Preliminary Design Road Safety Audit

**Tahimana Development
Tasman**

September 2024

2.1. Vertical Curves

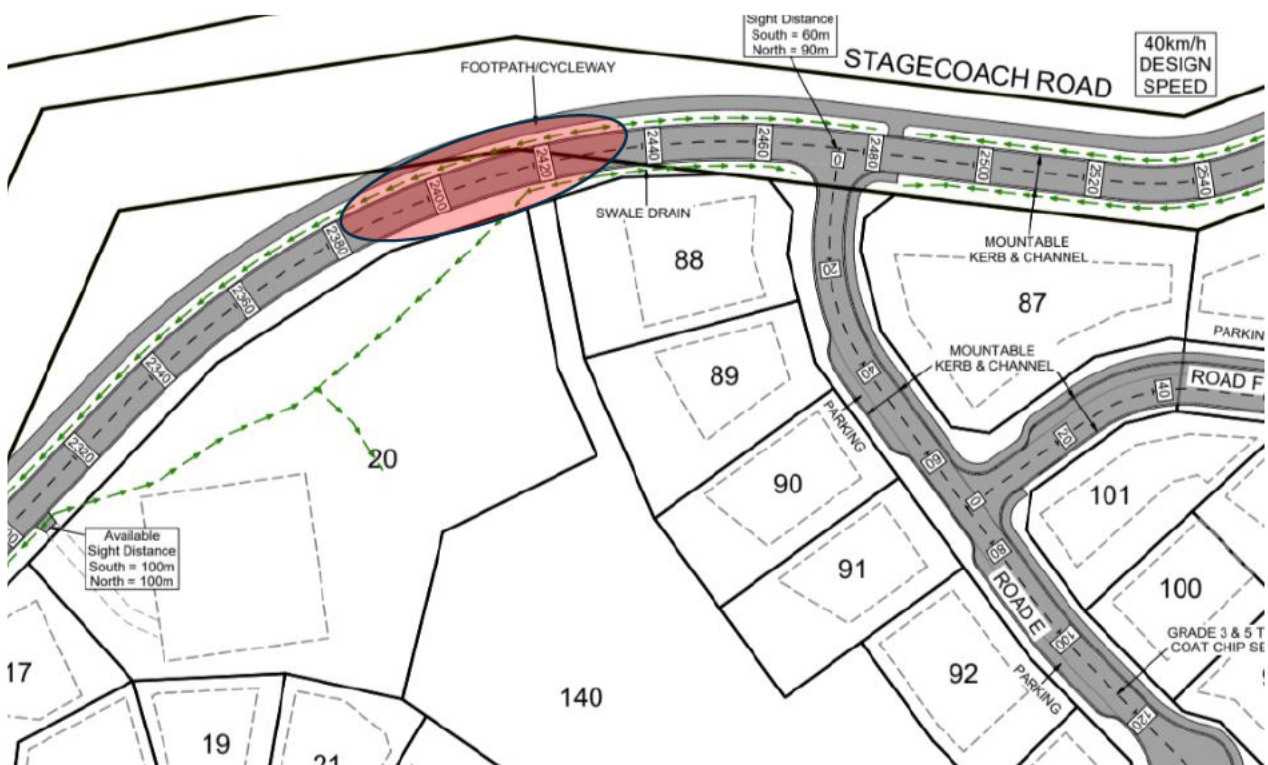
Several of the proposed vertical curves shown on the road longitudinal sections are less than the recommended design values for the corresponding design speed.

Vertical curves should be large enough with sufficient K values to enable safe stopping distance. Not providing sufficient vertical curves increases the risk and severity of crashes and especially in high operating speed environments. The auditors noted that the vertical curve at change 2400 on Stagecoach Road limits the safe stopping distance to the south. This issue is discussed separately below. The remaining vertical curves are considered under this section.

The design speed for the roads within the subdivision are expected to be 60 km/h or less. Head on crashes and run off road crashes could occur as a result of short forward sight lines. At 70 km/h these crashes can be more serious. With the operating speed expected to be less than 70 km/h the severity of a crash is likely to be minor.

1. Review the vertical curve design.
2. Consider designing vertical curves to meet the operating speed.

Significant	Frequency Rating: Unlikely	Severity Rating: Serious
Designer Response:	Vertical geometry to be reviewed at detailed design phase to ensure that SSD requirements are met for the appropriate design speed. Design speeds for roads within the development are to be: Road A 50km/h Roads B-G 30km/h	
Council Safety Engineer		
Client Decision		
Action Taken: (To be agreed between Council and the Client if needed.)

2.3. Stagecoach Road Curve Alignment (CH 1760 - 1900)

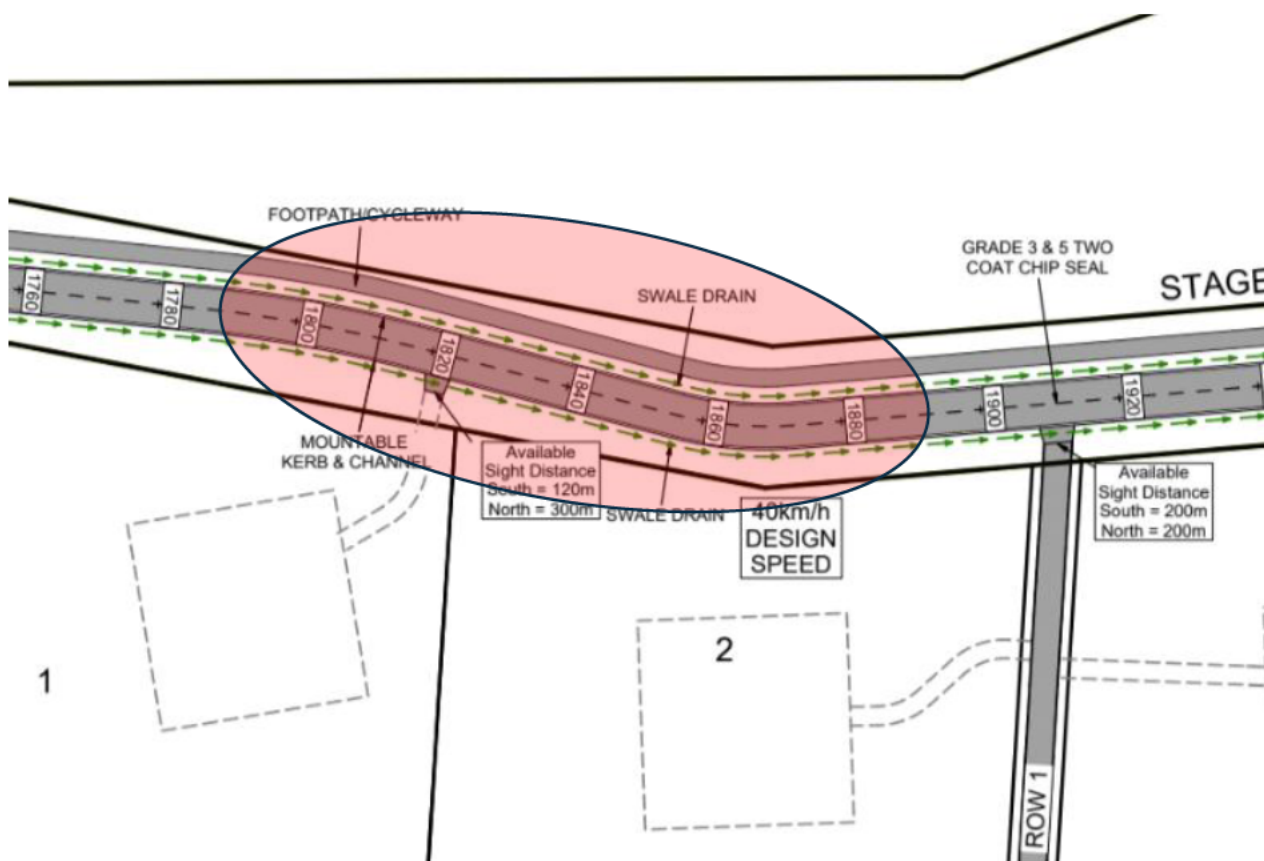
The proposed alignment of Stagecoach Road shows a reverse curve at CH 1800 leading into a smaller radius curve at CH 1860. This alignment may increase the risk of loss of control crashes, or head on crashes due to vehicles crossing the centreline. The design speed of 60 km/hr reduces the severity of the crash.

Head on and run off the road crashes above 70 km/h can lead to serious injury crashes. The design speed is less than 70 km/h and therefore the likelihood of a serious crash is low.

The curve at chainage 1860 has a design speed of 40 km/h which will help reduce the speed at chainage 1800. The curve at chainage 1860 will likely require an advisory speed sign which will also guide motorists to slow down as they approach the curve at chainage 1800.

1. Consider improving the geometry of the road by removing the curve at CH 1800 and increasing the radius at CH 1860.
2. Consider the installation of curve warning signs.

Minor	Frequency Rating: Unlikely	Severity Rating: Minor
Designer Response:	The design radius of the horizontal curve at CH1860 is to be reviewed at detailed design stage. Curve warning signs may be included in the detailed design if deemed appropriate as part of reviewing the horizontal curve.	
Council Safety Engineer		
Client Decision

2.4. Road C Longitudinal Section

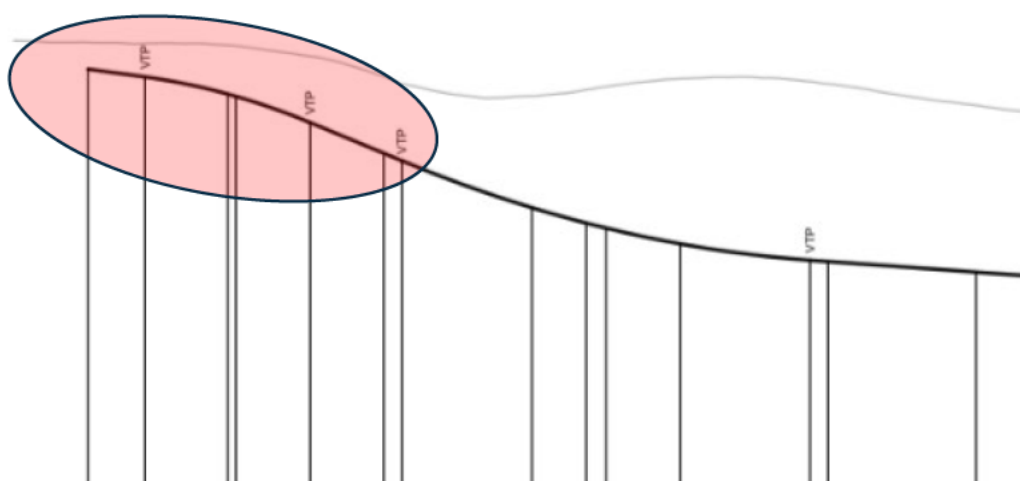
The longitudinal section of Road C shows a gradient at the intersection of Road A of 5.5% for 3.9m followed by a vertical curve and a downgrade of 16.65%.

Austroads design guidelines state “A steep upgrade on the approach to an intersection generally results in both sight distance and operational problems. Upgrades greater than 3% on the minor approach to an intersection are undesirable, especially where traffic has to stop before entering. Where such approach grades are necessary, preferred practice is to grade the road at 3% or less for a minimum distance of 10 m from the lip of the channel or edge line (maximum of 4%)”

The crash side impact speeds at the intersection of Road A and Road C are likely to be less than 60 km/h. This operating speed is likely to be a minor injury rather than a serious injury. The good approach sight lines also provide some mitigation of a potential crash and reduced impact speeds.

1. Reconsider the vertical geometry at Road C to provide a flatter slope at the intersection for the first 10 metres.

Minor	Frequency Rating: Very Unlikely	Severity Rating: Minor
Designer Response:	Review and redesign if necessary at detailed design stage to flatten slope of waiting area.	
Council Safety Engineer		
Client Decision		
Action Taken: (To be agreed between Council and the Client if needed.)
